19 December 2025

Buller District Council
PO Box 21
WESTPORT 7866

JOHN RAYMOND MCLAUGHLIN – RC250005 REQUEST FOR FURTHER INFORMATION UNDER S92

Updated Scheme Plan

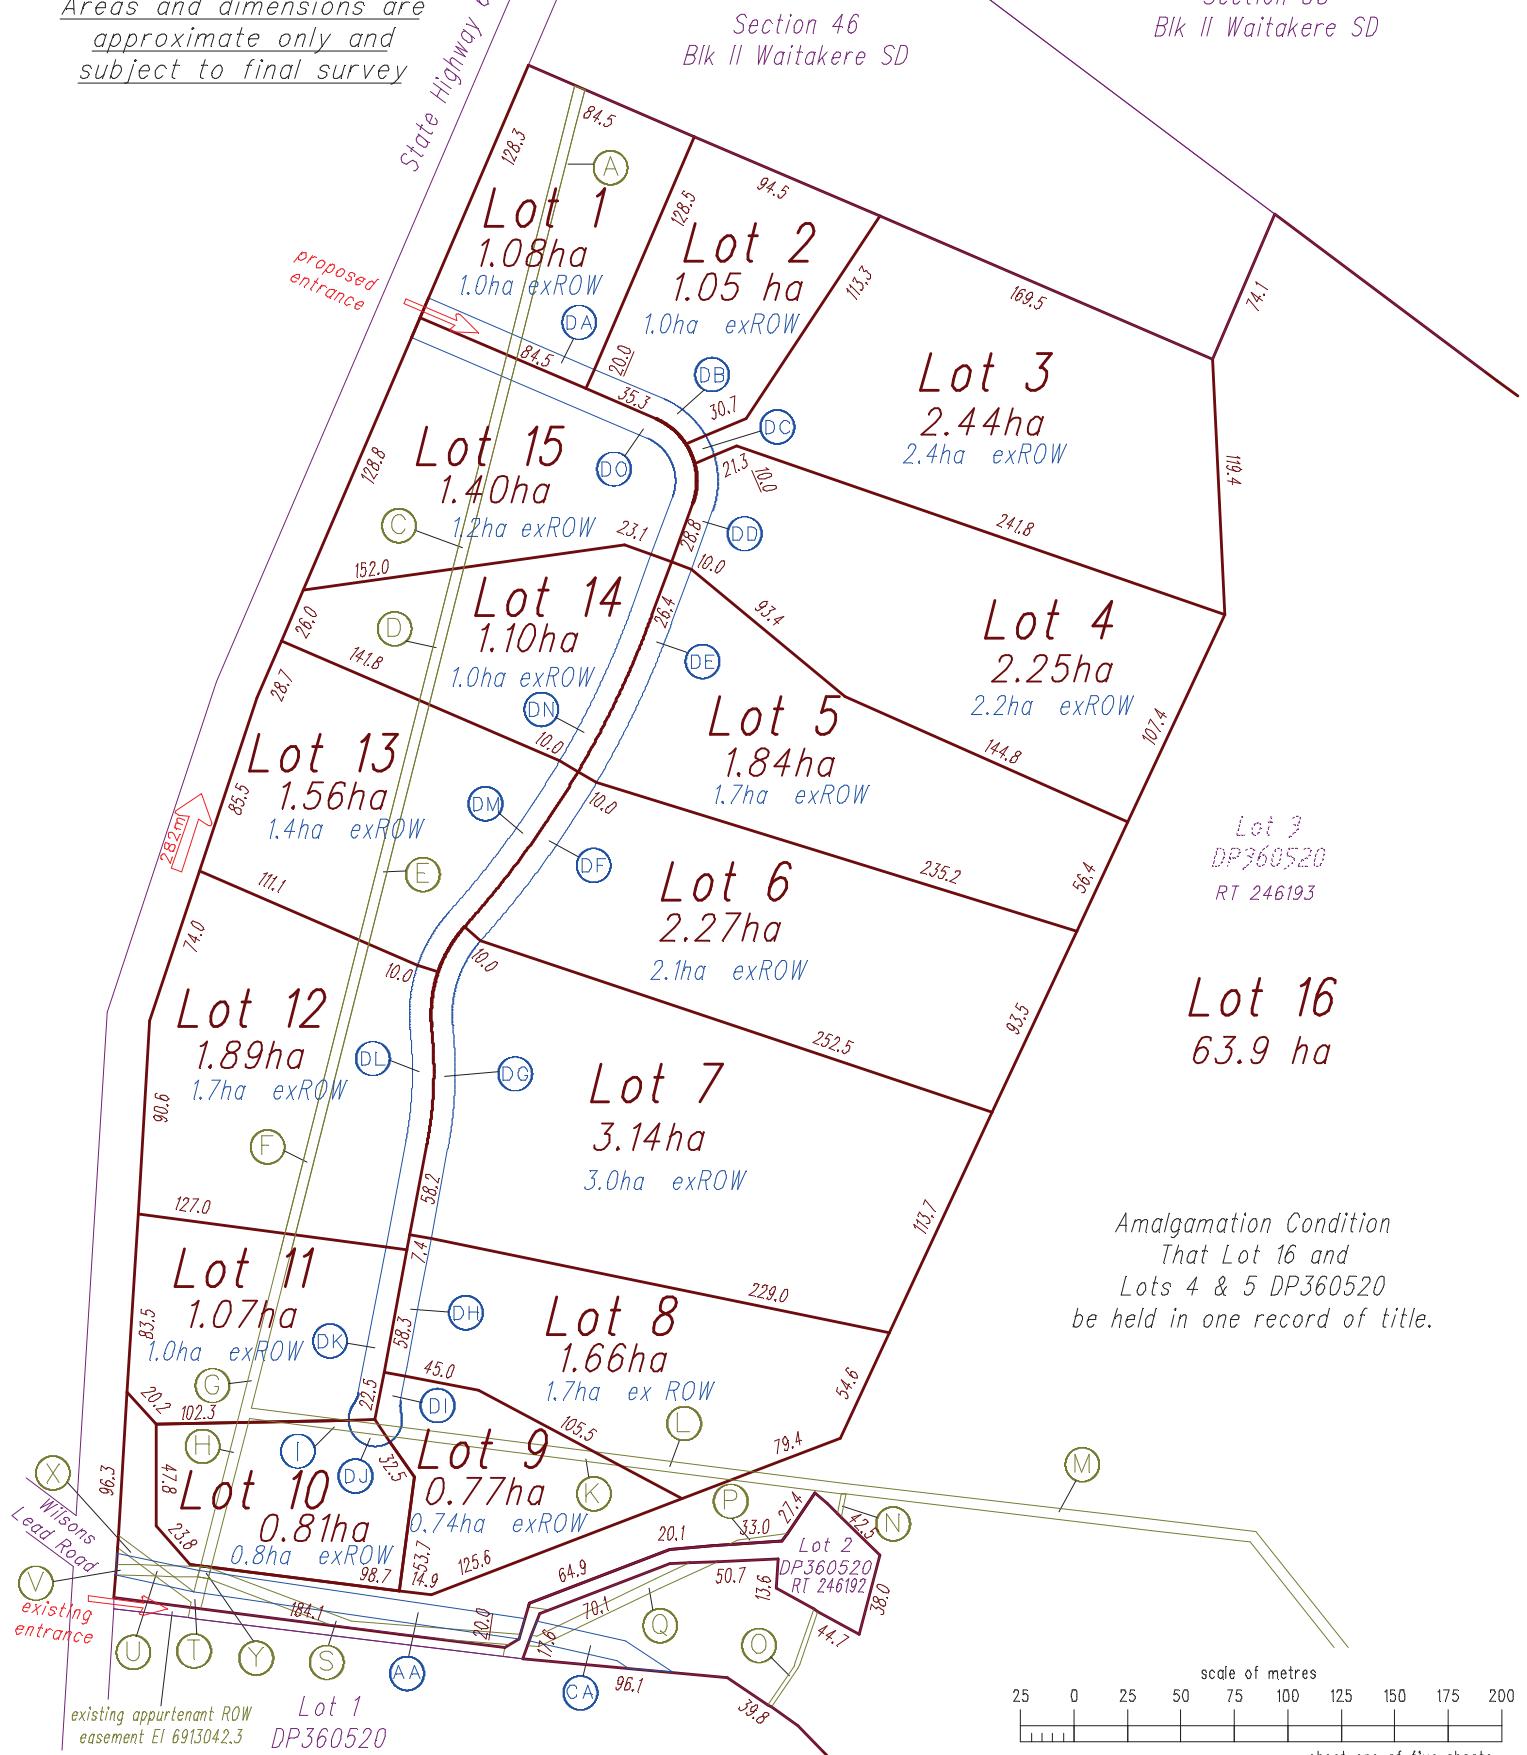
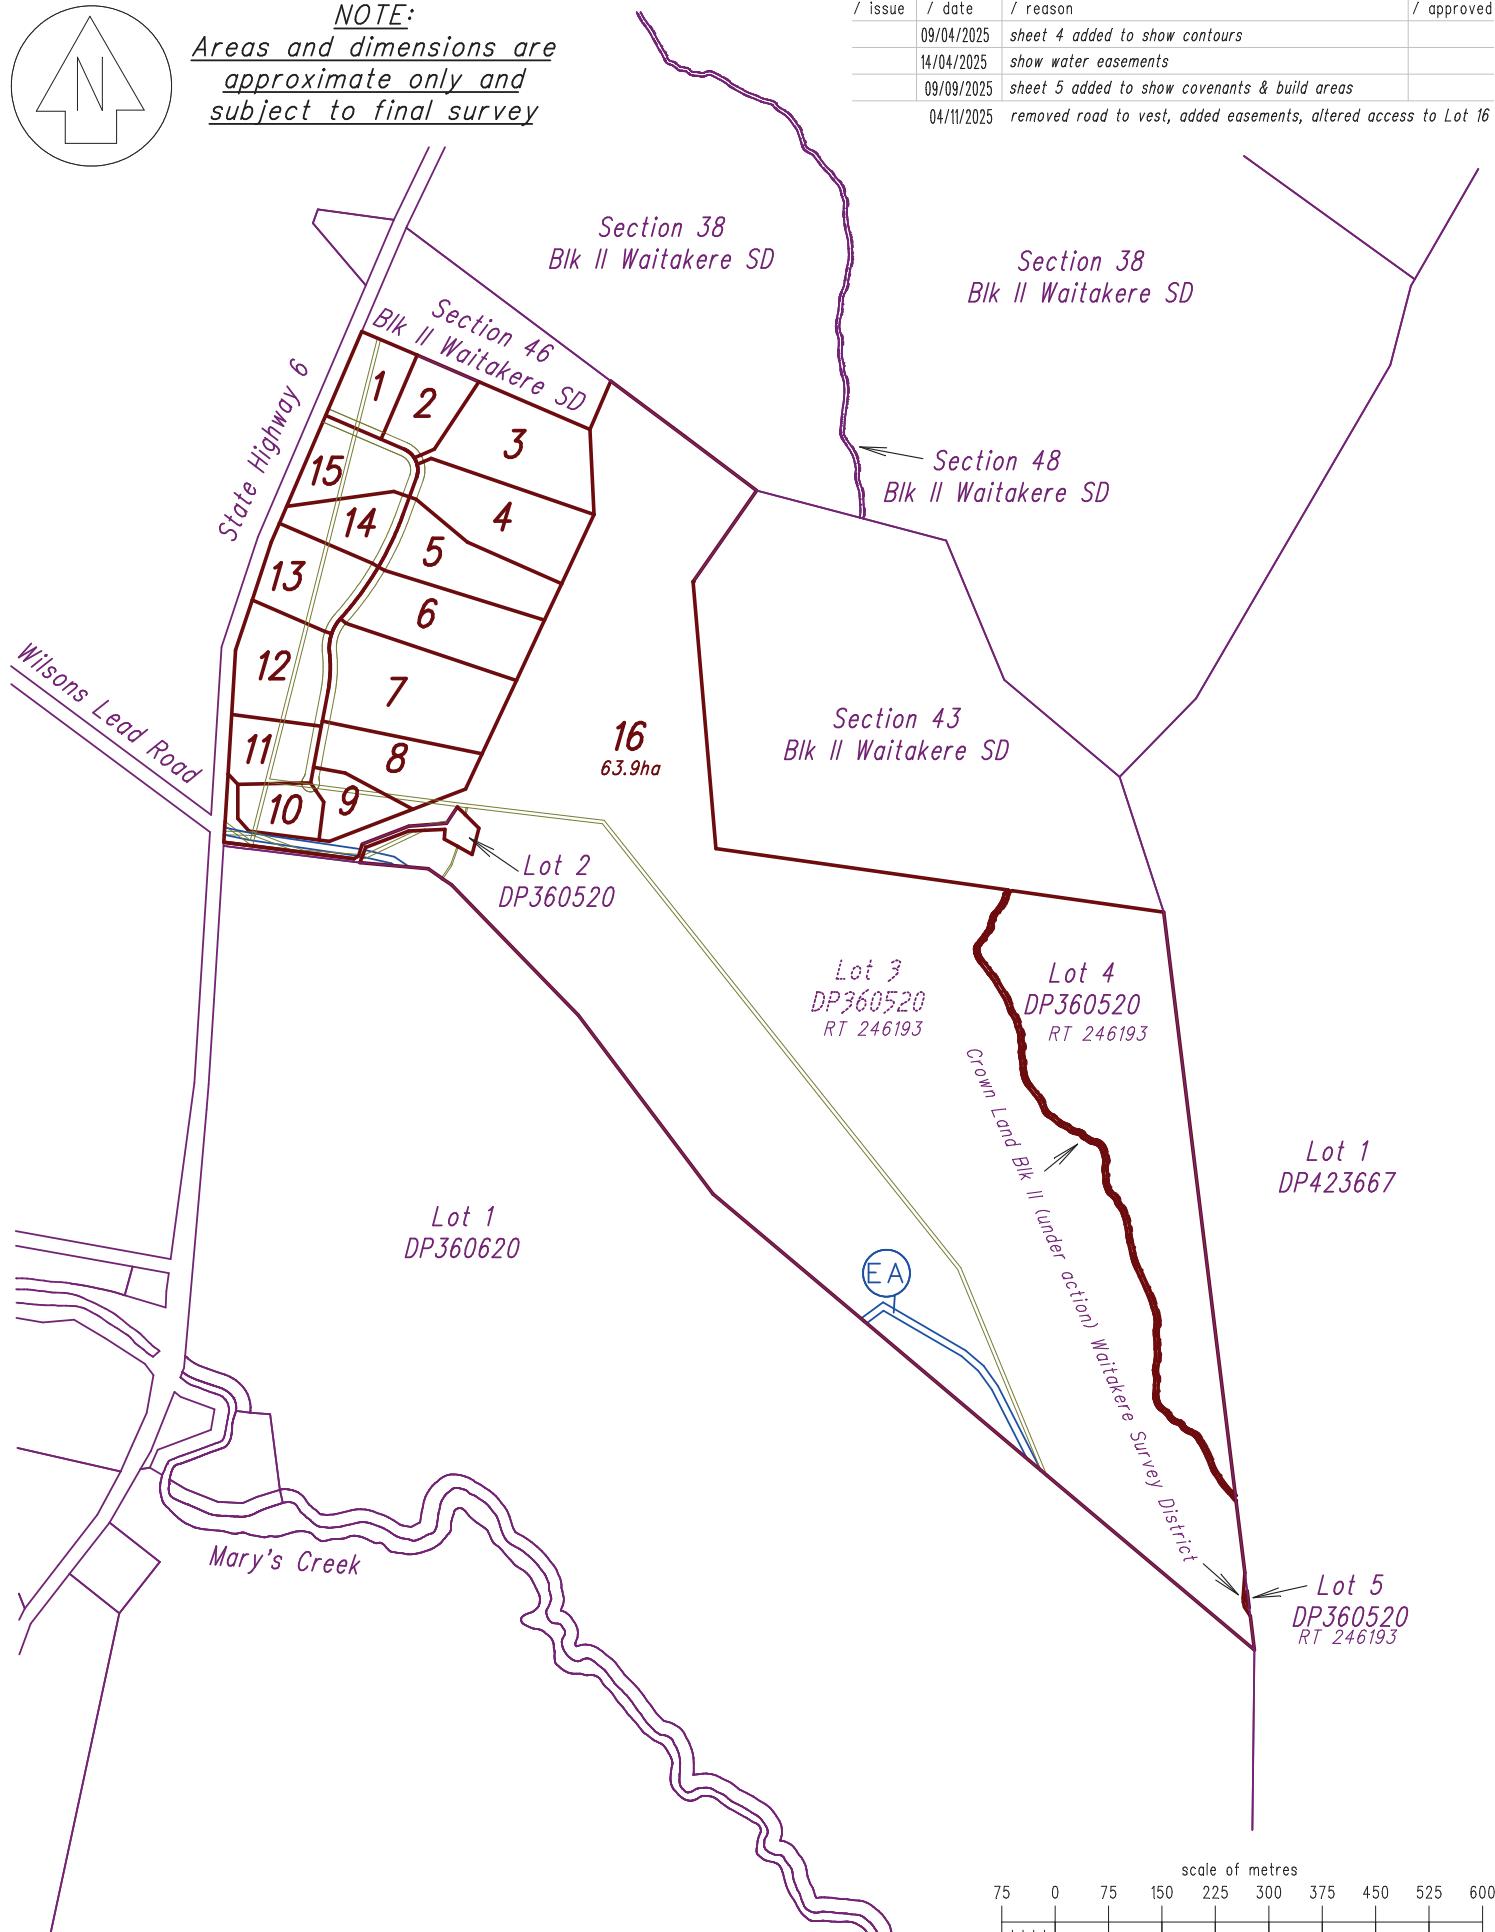
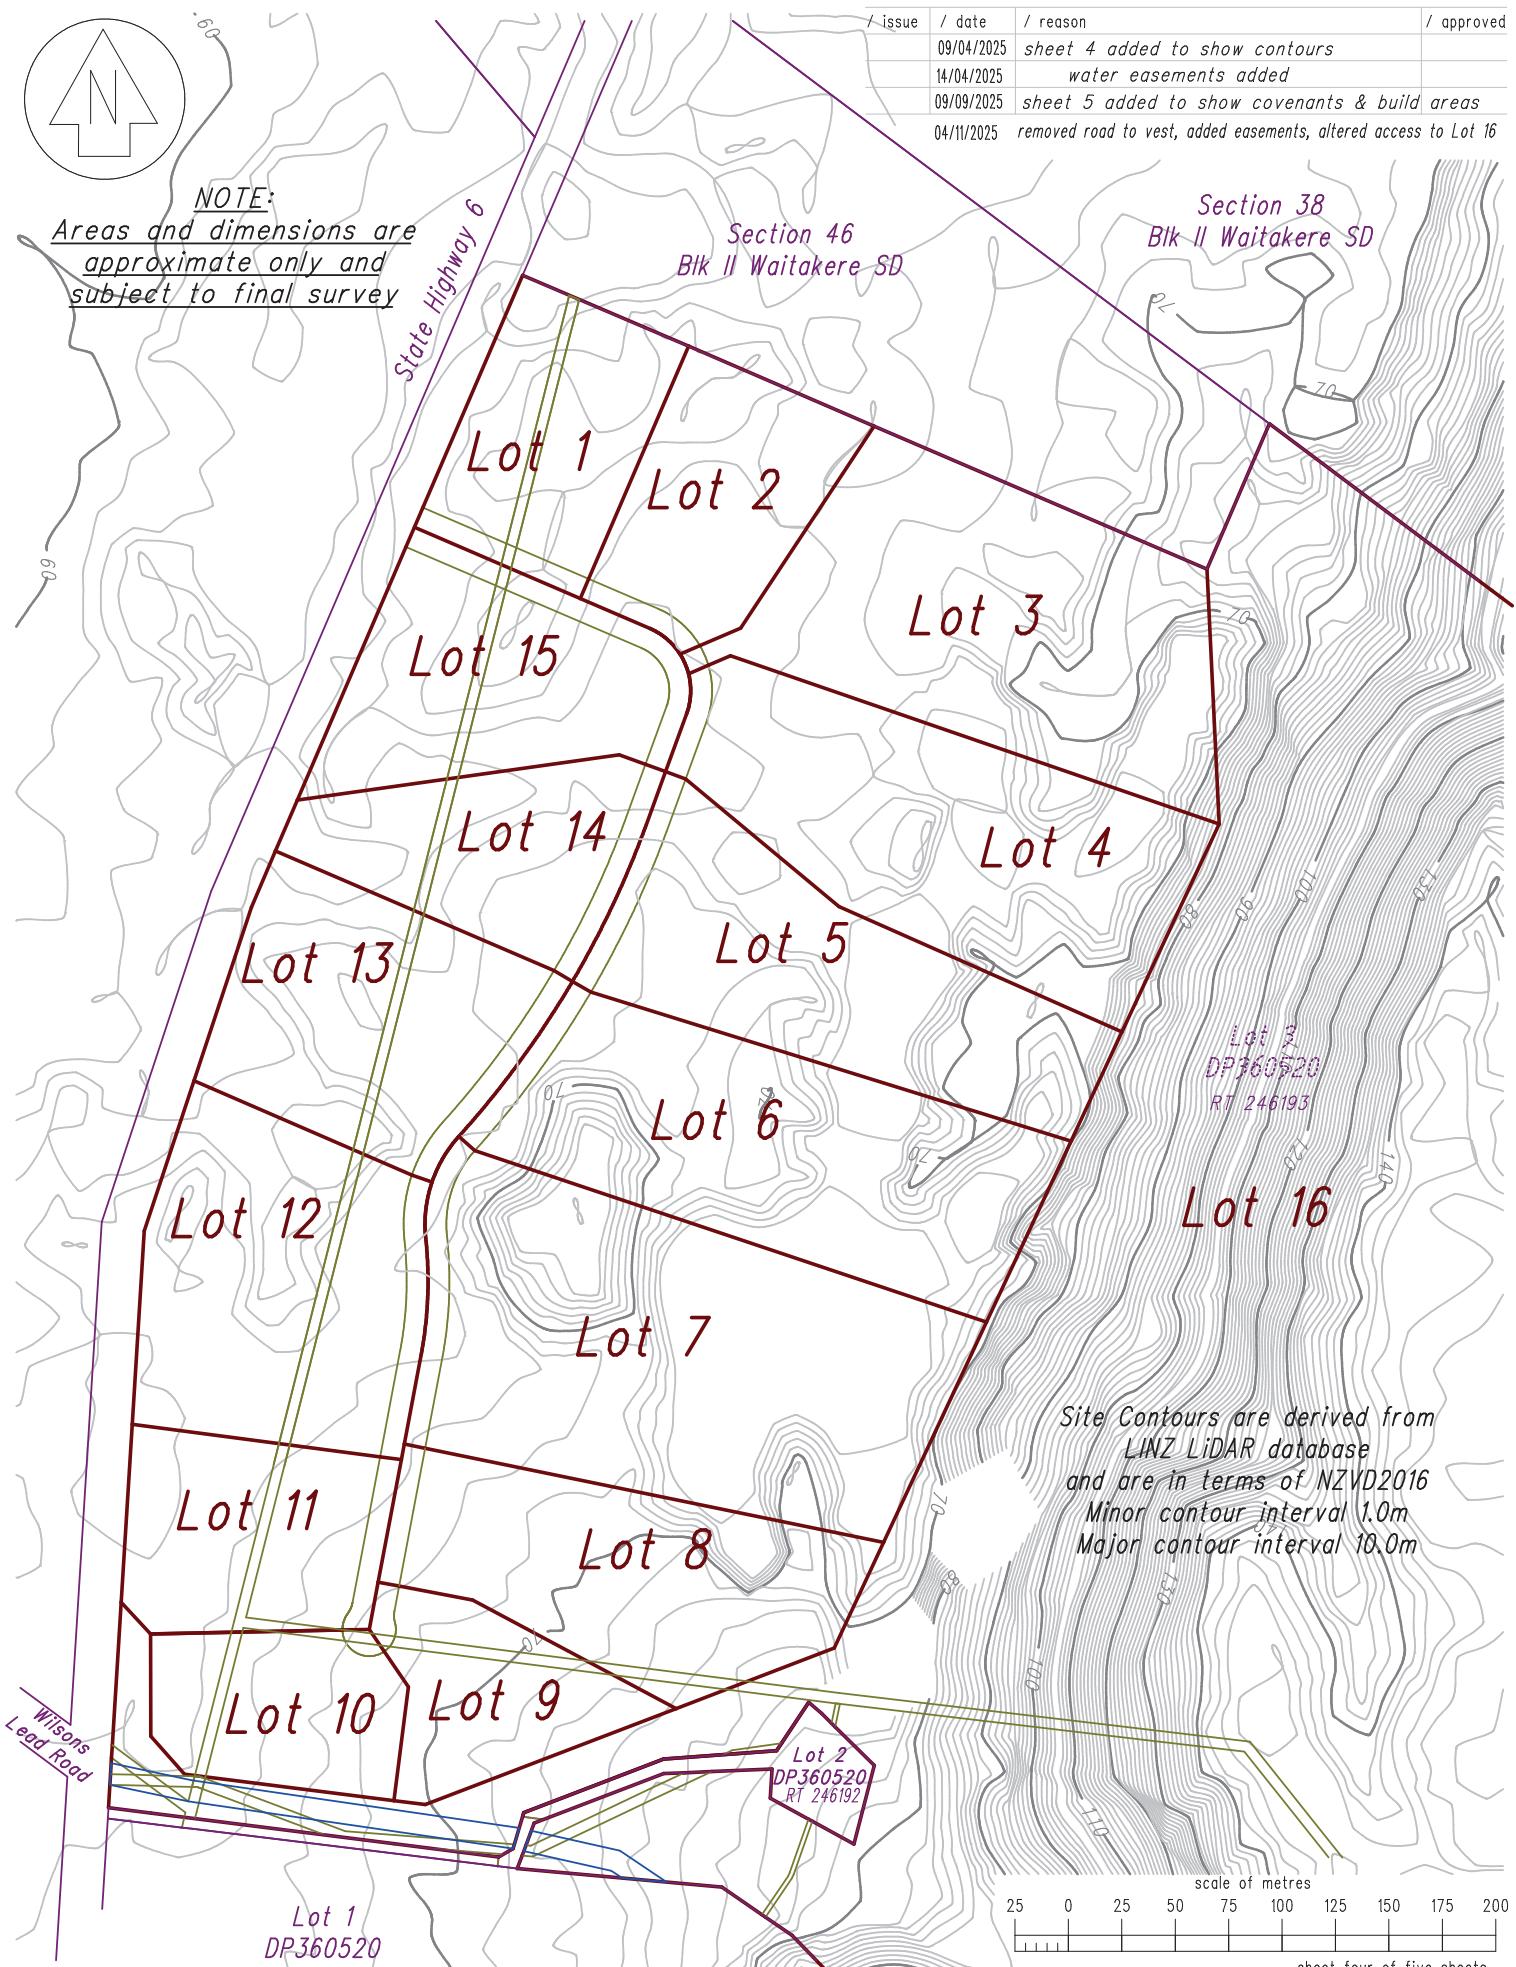
As per email correspondence with Sarie van der Walt of Buller District Council (correspondence attached as **Appendix A**), Sarie has made it very clear that Buller District Council will not be accepting Lot 18 as a vested road. As a result, the applicant has chosen to proceed with Lots 1 to 15 being accessed via a right of way, in favour of the 15 allotments.

Please note the minor change to the south-eastern boundaries of Lots 8 and 9 and access to the balance land is discussed under the heading "Access to Lot 17- 8 October 2025" below.

Section 3.1.2 of the application explains that easement R is required to provide access over Lot 2 DP 360520 to enable access to proposed Lot 17 and Lots 4 and 5 DP 360520. If easement R is not provided for, then the applicant will not have access to proposed Lot 17 of the subdivision. It was an omission that Lot 2 DP 360520 did not form part of the subdivision consent application. The owner of Lot 2 360520 is a family member. Affected party approval is in the process of being obtained and will be provided once received.

An updated Scheme Plan showing Lot 18 being replaced with the right of way is attached to this response as **Appendix B**. Also attached as **Appendix C** is an updated proposed easement schedule.

As a result of the creation of the right of way, the boundaries of Lots 1 to 15 have been amended to include the easements necessary for the right of way. This has resulted in minor changes to the size of Lots 1 to 15, that will not impact on the ability to undertake building development on each allotment. The change in area of each allotment considered to have less than minor effects on the environment as they are for the purpose of providing access to each allotment. Therefore, these changes are considered to be positive and achieves the relevant objectives and policies within the Buller District Plan.

An updated Scheme Plan is attached to this response. The Scheme Plan shows the boundaries of Lots 8 and 9 have been amended to enable access to the balance land to be to the northwest of Lot 2 DP 360520. On previous versions of the Scheme Plan, the balance land was identified as Lot 17. As access to the balance land is not required over Lot 2 DP 360520, a separate allotment is not required for the

balance land. Therefore Lot 17 has been combined with the area previously identified as Lot 16 to create a new Lot 16 that is 63.9 hectares in area.

To be clear easement R is not required and Lot 16 will not have access from the newly proposed right of way.

This change results in lots 8 and 9 each being reduced in size by approximately 2000m². This change does not compromise the ability for building development to occur on Lots 8 or 9 in the future. Rule 7.4.2 of the Buller District Plan requires every owner or occupier of land to provide vehicular access to the site for parking and loading over the site by provision of a vehicle crossing constructed to the boundary of the site. The change to this scheme plan ensures the subdivision complies with Rule 7.4.2 as all allotments will be provided with vehicular access. Therefore, this change is considered to have less than minor effects on the environment, with these being positive, and it will achieve the relevant objectives and policies within the Buller District Plan. I trust this response address the email dated 8 October 2025.
